### 142.2.4 FEC encoder

#### 142.2.4.1 Low ~~Density Parity Check~~ density parity check coding

Figure 142–1—FEC encoder

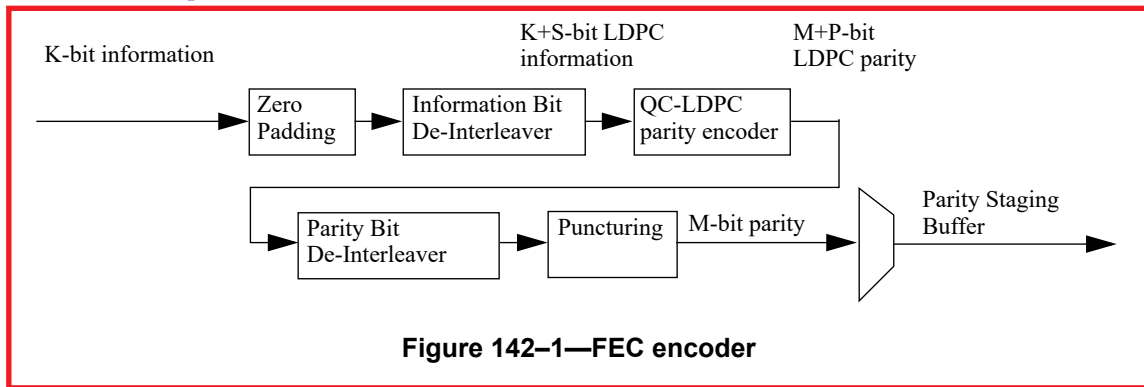
The LDPC encoder as shown in Figure 142–1 places the  $M$ -bit FEC parity bits into the *ParityStagingBuffer* for use by the PCS Transmit Process (see 142.2.5.4.3) and the *FecParity()* function. The buffer is comprised of 2560 bits of calculated parity along with the 10-bit codeword delimiter (*FEC\_CW\_DELIM*). This results in the parity bits assigned to *ParityStagingBuffer*<2559:0> and the 10-bit *FEC\_CW\_DELIM* value to *ParityStagingBuffer*<2569:2560>. The transmission order starts with bit 0 and ends with bit 2569.

Figure 142-6—FEC encoder

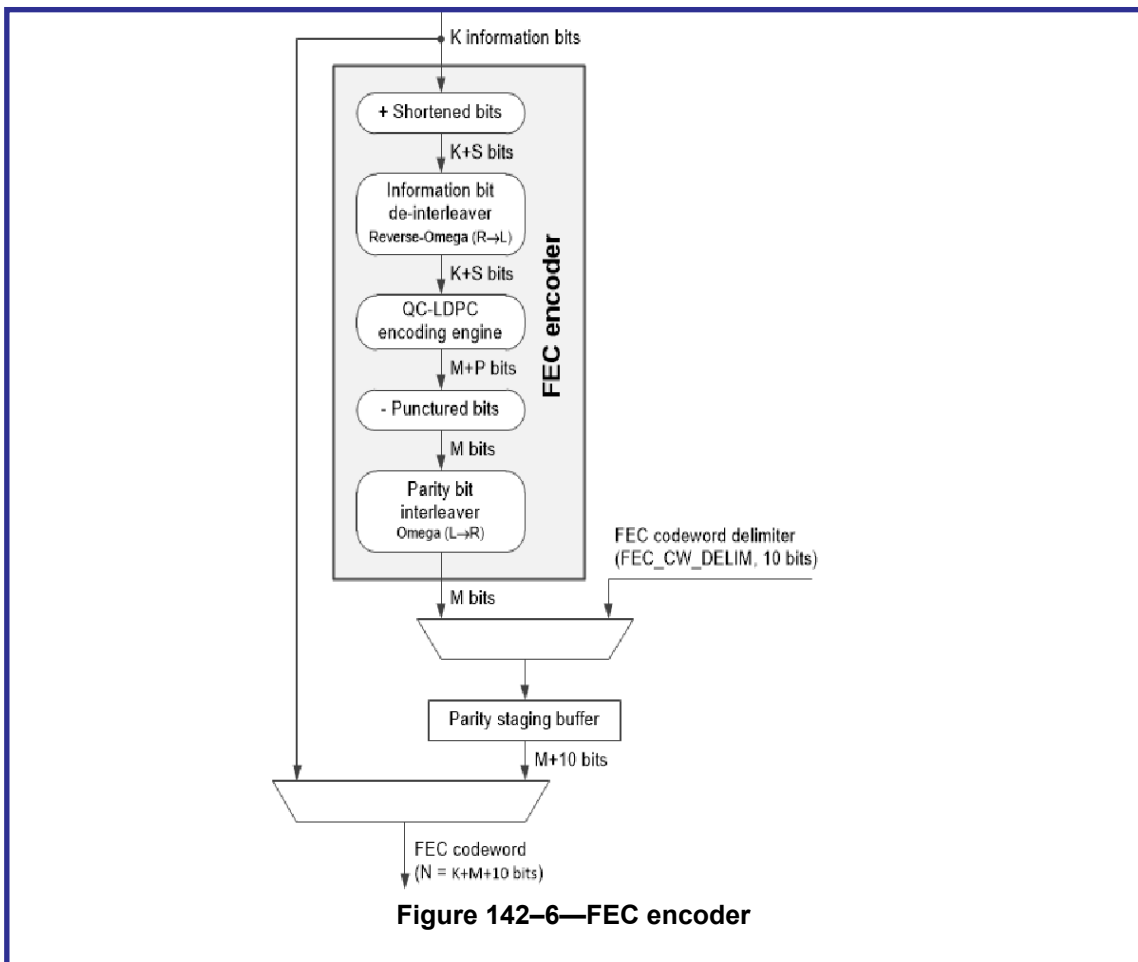
The FEC ~~encoding scheme encoder~~ is shown in Figure 142–6. The ~~scheme encoder~~ consists of a systematic QC-LDPC ~~encoder and encoding engine followed by~~ a shortening and puncturing ~~mechanism~~ and the addition of a 10-bit delimiter. The parameters of the FEC ~~encoding scheme encoder~~ are:

- the LDPC parity check matrix is a 12-by-69 ~~quasiarray of circulant sub-eyelie matrix, matrices (see 142.2.4.1)~~ with circulant size  $Z = 256$ ; LDPC user bit length before shortening is  $57 \times 256 = 14592$ , the parity bit length before puncturing is  $12 \times 256 = 3072$ ; the codeword length before any shortening and puncturing is 17664;

- the number of transmitted information bits,  $K$  (with maximum user length  $K_{\max} = 14392$ );
- the number of shortened information bits,  $S$  ( $S_{\min} = 200$ ,  $14592 - K$ );

- the number of punctured parity check bits,  $P$  ( $P = 512$ );
- the number of parity-check bits after puncturing,  $M$  ( $M = 3072 - 512P = 2560$ );

- the ~~number length of the FEC encoder output bits, + delimiter is~~  $N$  (where  $N = K + M$ , ~~FEC code word, whose size depends on the burst length pattern to determine shortening length~~); ~~+ 10-bits and~~  $N_{\max} = K_{\max} + M + 10\text{-bits} = 16952$ ; ~~16962~~;
